DANNY LIPFORD SUBDIVISION

The purpose of this application is to create a 1-lot subdivision from two metes and bounds parcels.

APPLICATION NUMBER 20 DATE April 7, 2005

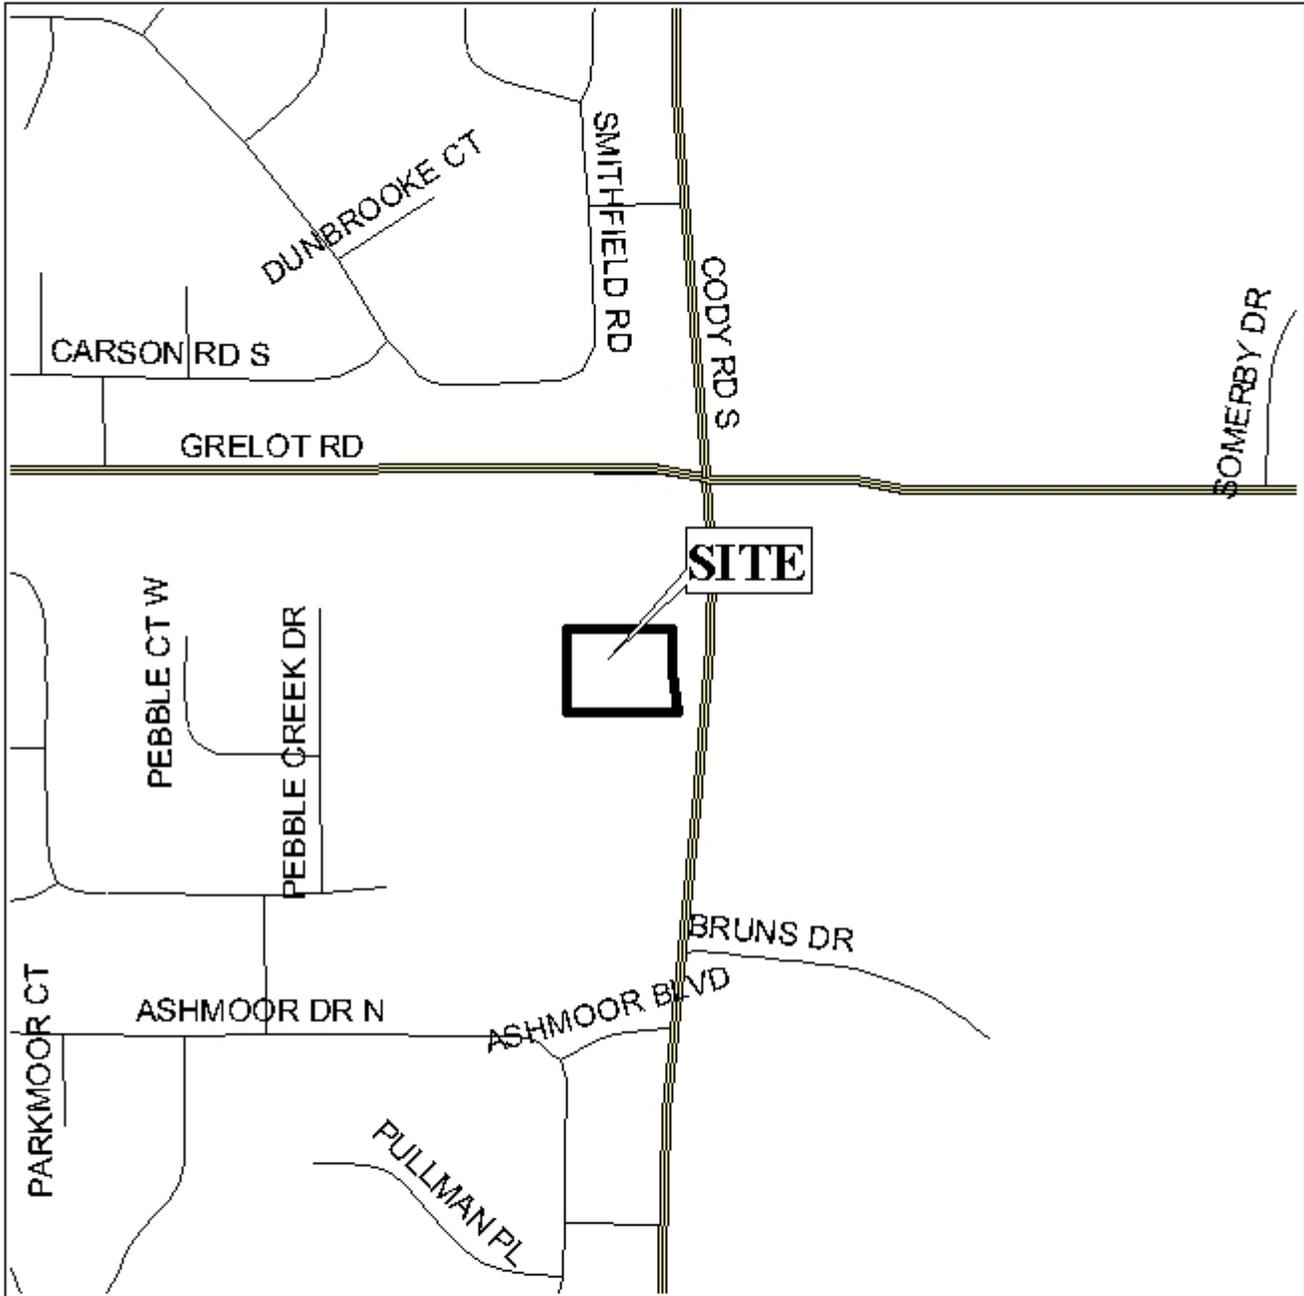
The site fronts Cody Road, a planned major street, and the right-of-way is illustrated as variable; therefore, the dedication of any necessary right-of-way to provide 50-feet from the centerline of Cody Road should be required. Additionally, since the site will have approximately 208-foot of road frontage on a major street, access management is a concern; therefore, a note should be placed on the final plat stating that the development is limited to one curb cut to Cody Road, with the size, location and design to be approved by County Engineering.

Since the site is located in the County, thus a note should be placed on the final plat stating that any lots which are developed commercially and adjoin residentially developed property, shall provide a buffer, in compliance with Section V.A.7. of the Subdivision Regulations.

The required twenty-five foot minimum building setback line is not illustrated, but will be required on the final plat.

With modifications, the plat will meet the minimum requirements of the Subdivision Regulations and is recommended for Tentative Approval subject to the following conditions: 1) dedication of any necessary right-of-way to provide 50-feet from the centerline of Cody Road, a planned major street; 2) the placement of a note on the final plat stating that the development is limited to one curb cut, to Cody Road, with the size, location and design to be approved County Engineering; and 3) the placement of a note on the final plat stating that any lot that is developed commercially and adjoins residentially developed property shall provide a buffer, in compliance with Section V.A.7. of the Subdivision Regulations; and 4) placement of the required 25-foot minimum building setback line on the final plat.
